# **Martin Place, Over Station Development, North Site**

## **Architectural Design Statement**

**22/04/22**

## Architects Statement

**Proposed South Elevation**

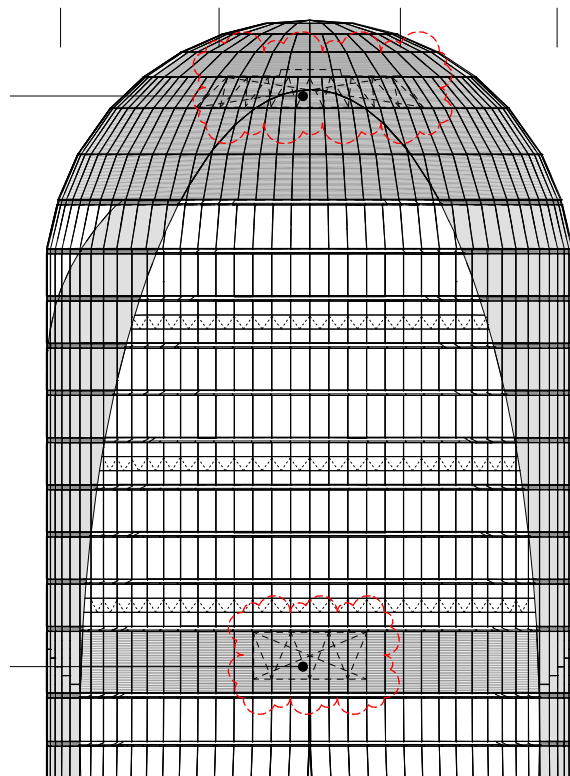
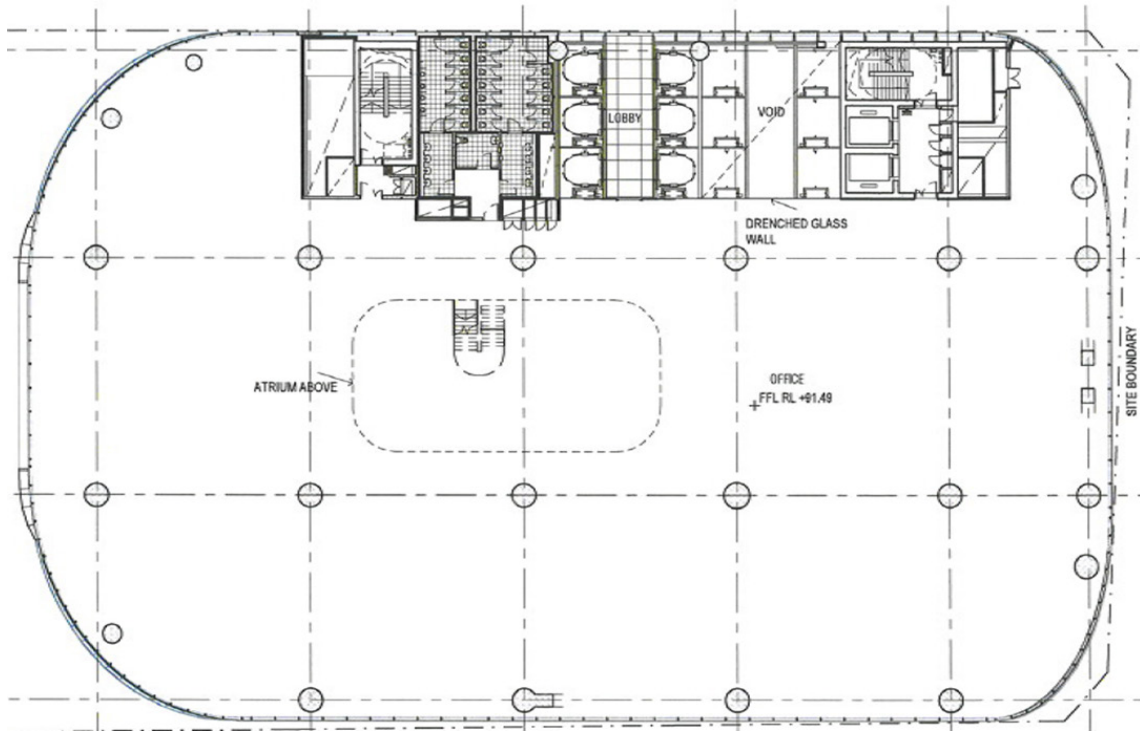
The approved south elevation includes BMU openings on Level 15 and Level 28 plant areas within the louvre facade zone.

During design development with the subcontractor, the openings have reduced in size.

**Proposed Level 16 Plan**  
Typical example floor

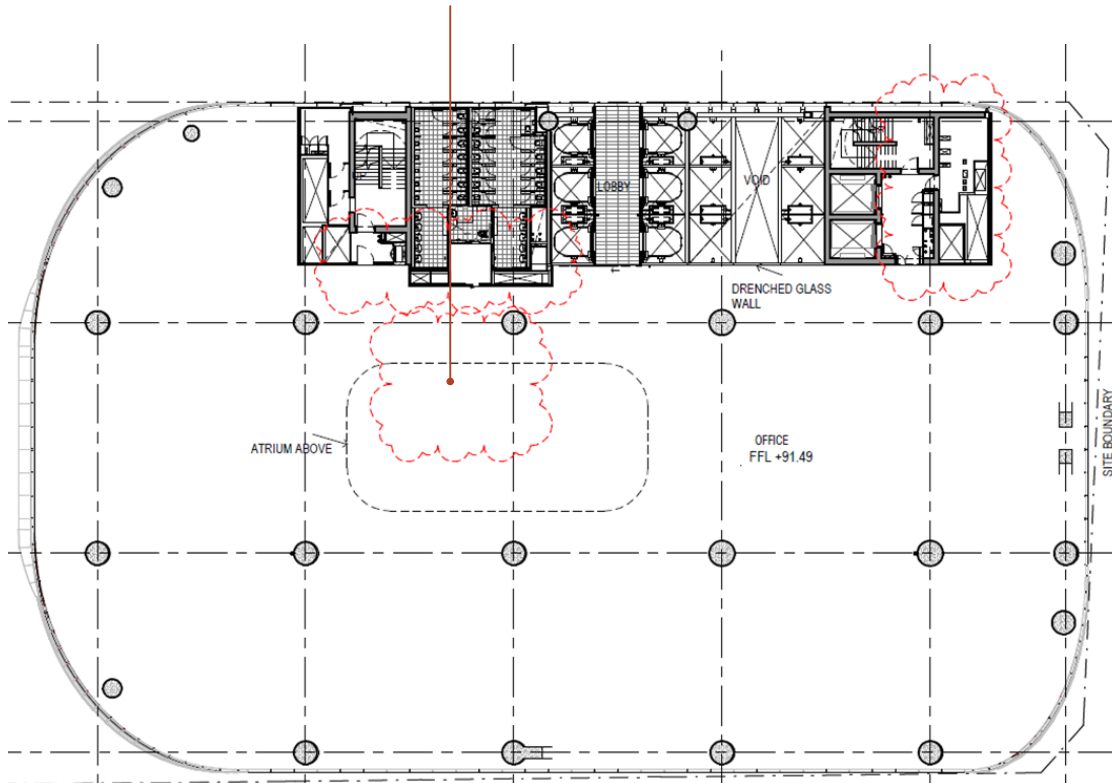
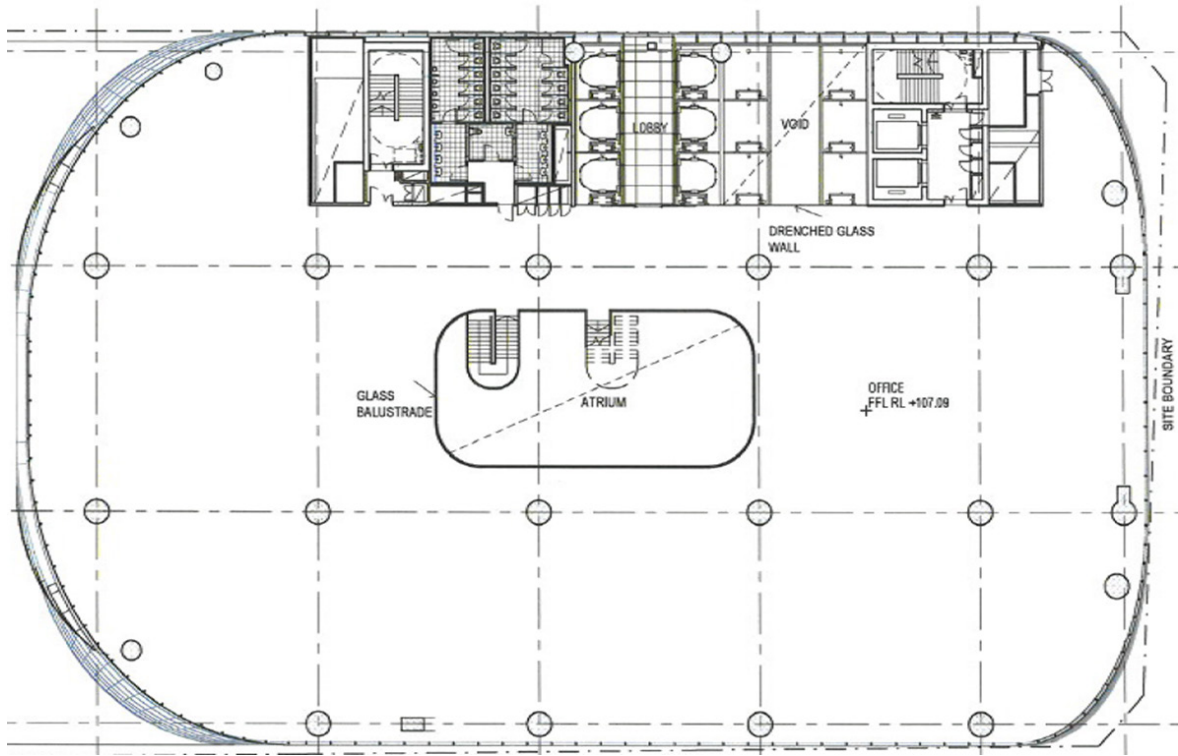
During design development there have been client initiated changes to the size and geometry of select atriums and to the size and location of inter-tenancy stairs. The changes have been made to suit updated integrated fitout requirements and are minor in nature.

Example of removal of  
inter-tenancy stair

**Proposed East Elevation**

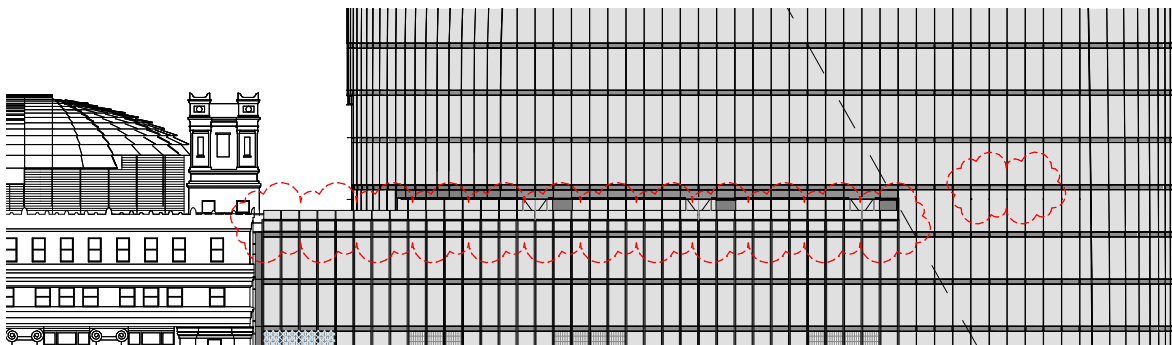
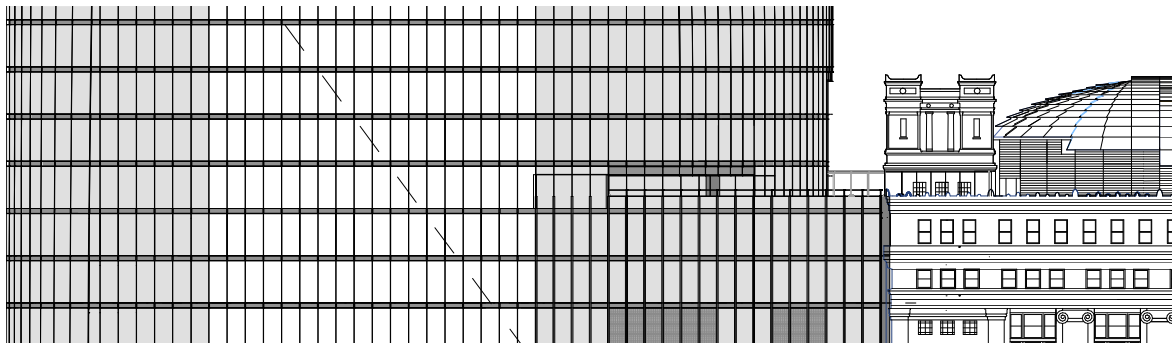
During design development the client instructed an increase in height of the terrace balustrade to 1800mm. The approved facade parapet height and alignment to 50 Martin Place is maintained.

**Proposed Level 29 Plan**  
Typical example floor

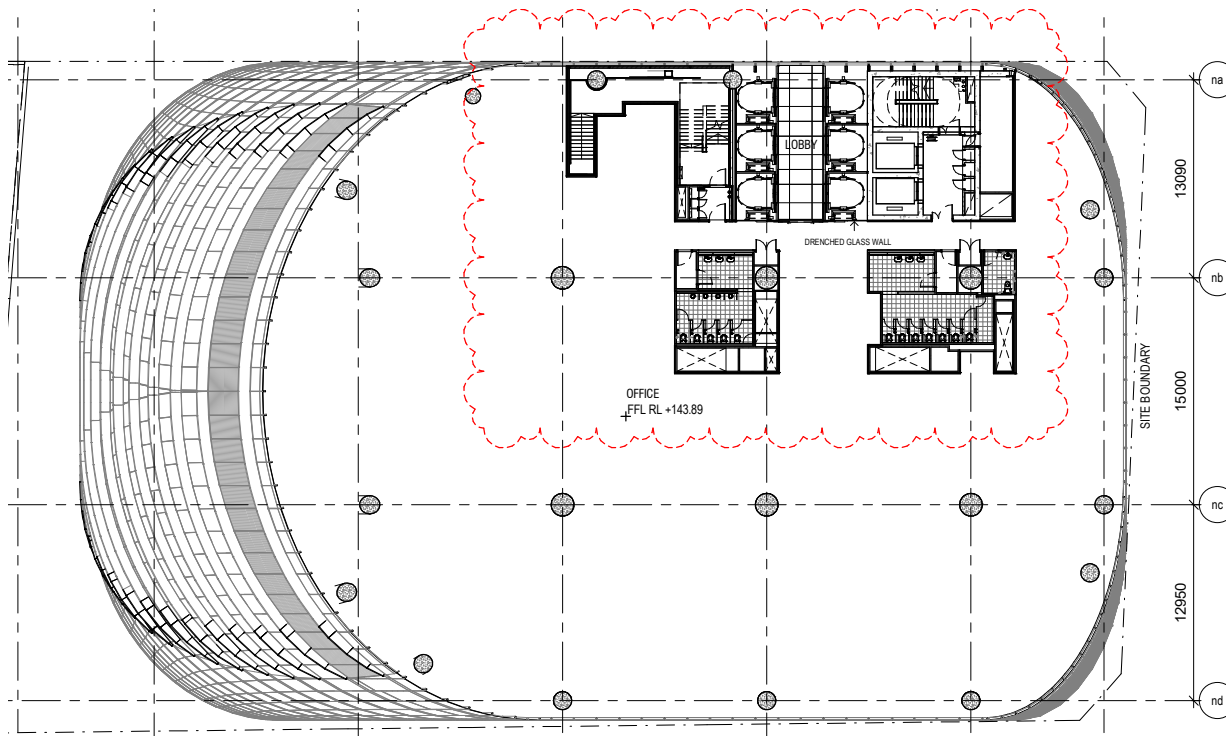
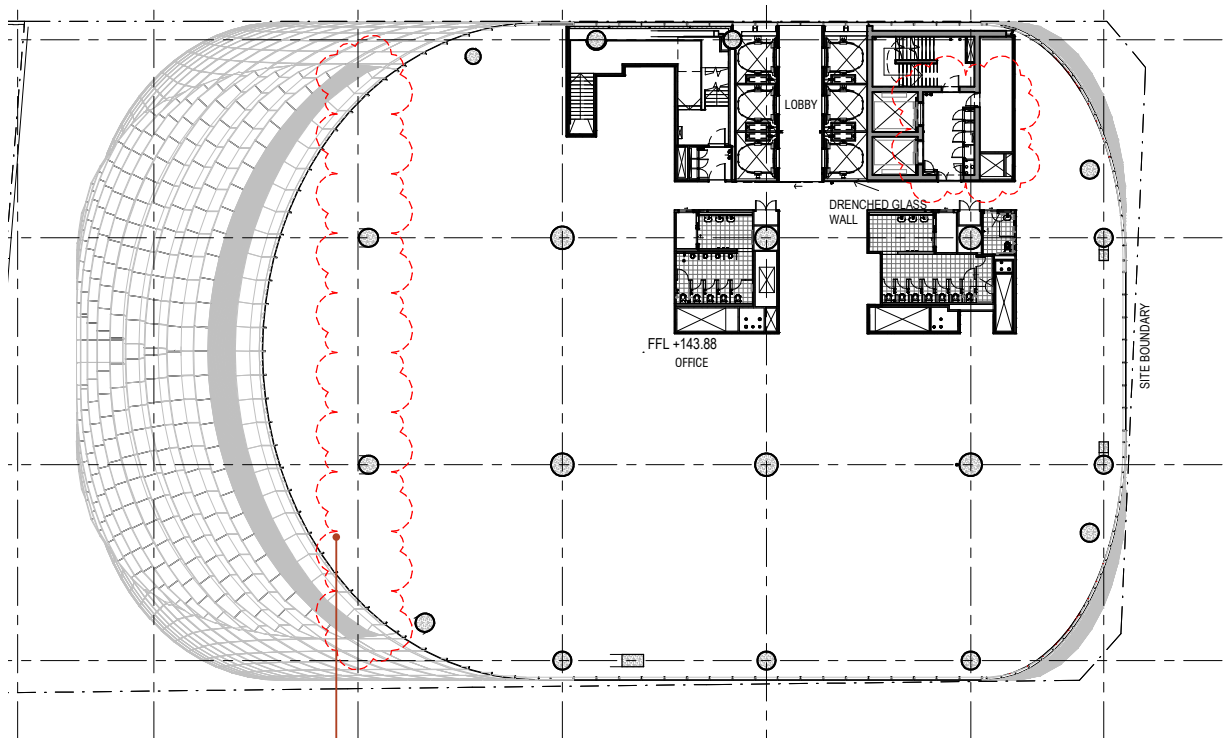
The approved high rise workplace floors include inclined columns at the southern end of the floorplate. During the design development process the structure has been rationalised which allowed for the removal of some columns and minor adjustment to the alignment of the remaining columns.

Example of removal of columns

Proposed East Elevation

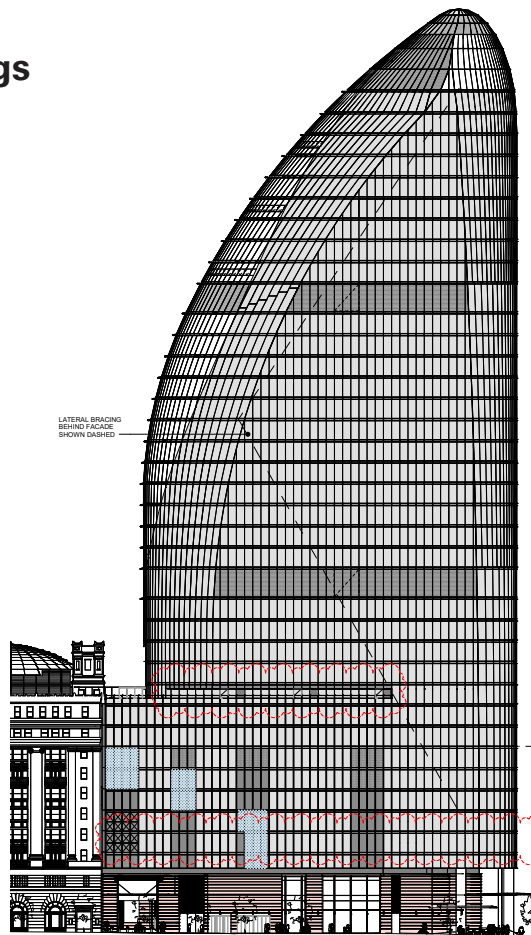
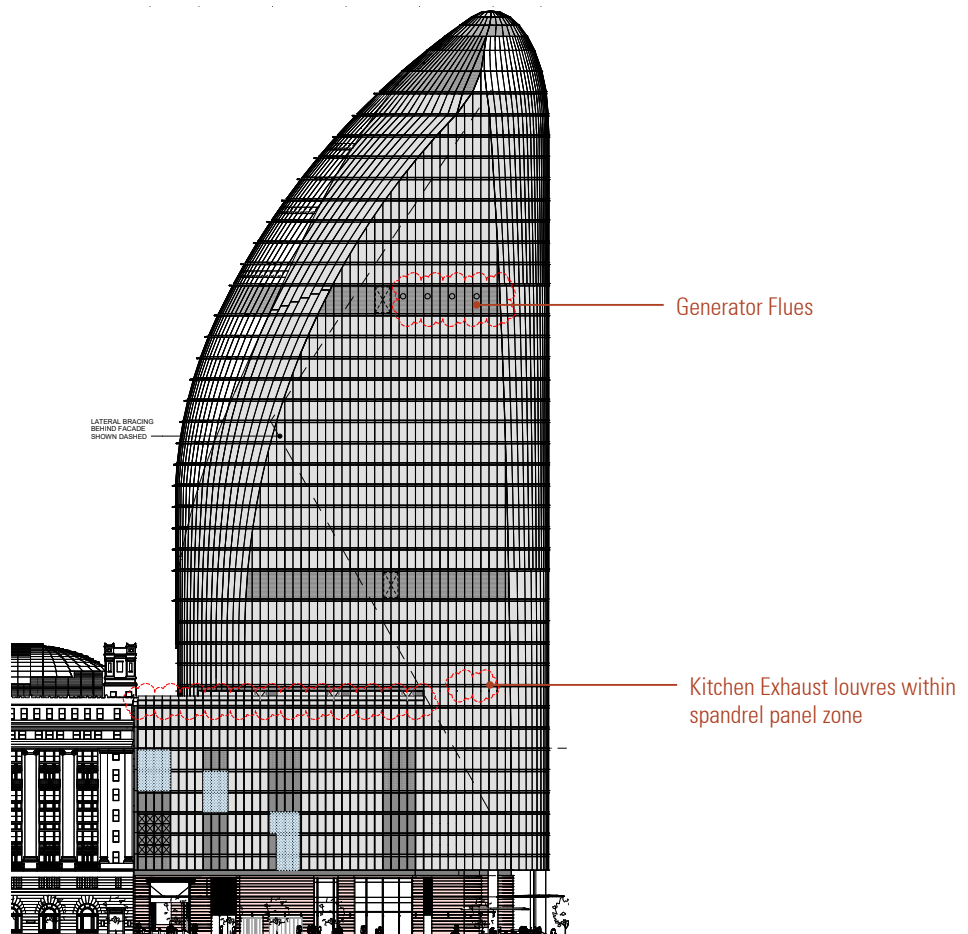
- Client fitout requirements have necessitated the addition of new kitchen exhaust louvres on L11. These louvres are located within the existing recessed aluminium spandrel zone of the facade panels and make minimal difference to the facade appearance and presentation of the building.
- The substation removal hatches on L15 and L28 have been reduced in size.
- Generator flue requirements have been clarified for L28. These were previously not shown on the approved DA drawings and they are now shown. The flues are integrated into the facade louvre panels and have been coordinated to be located centrally within the louvre panels. They do not project beyond the facade line. They are detailed to finish flush with the face of the louvres.

Proposed West Elevation

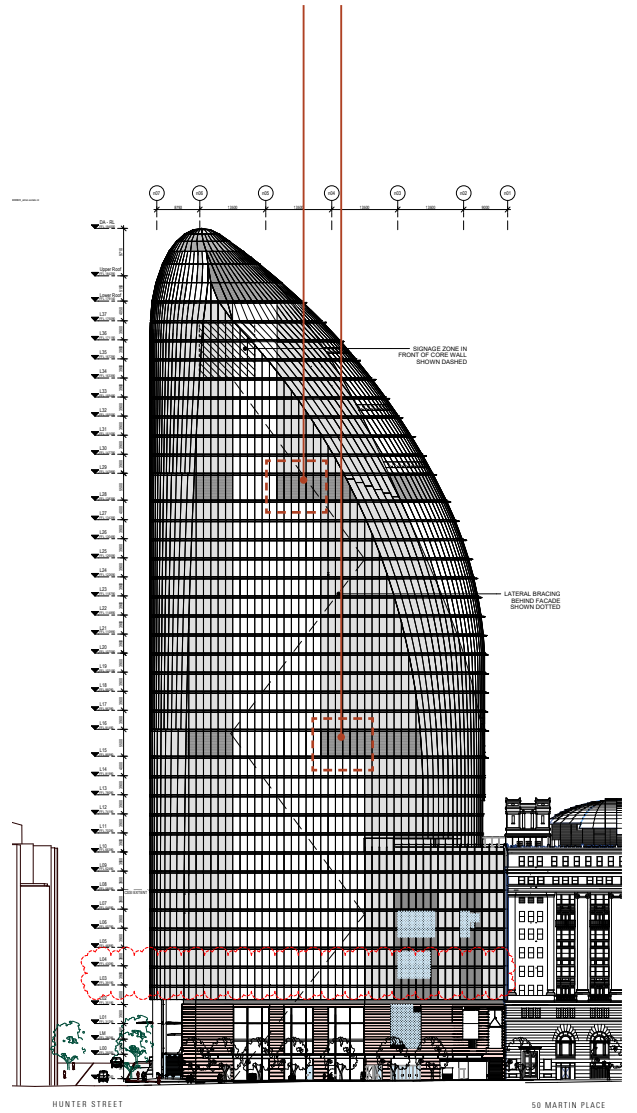
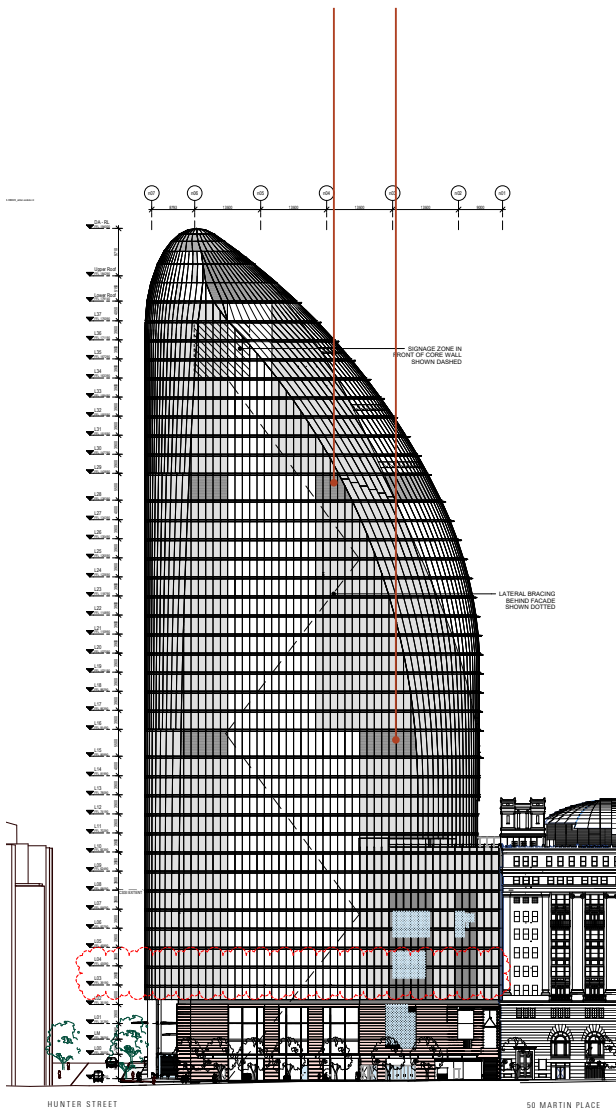
During design development, additional fire rating and fire separation requirements have been determined for the Lift Motor Rooms and the supporting structure. The fire-rating and fire-separation elements are required to meet the façade but cannot be aligned with the approved façade modulation and hence would be visible against and through the current clear glazing façade system.

To achieve a high quality, visually consistent outcome, the proposed modification extends the adjacent plantroom facade louvres across the lift motor plant room façade. The modification will conceal the connections of the required Lift Motor Room fire rating and fire separation elements to the façade. The modification will ensure design excellence is maintained and has no material impact on the overall appearance and presentation of the building.

Extend louvre panels across lift motor rooms on L15 and L28 (6 panels)
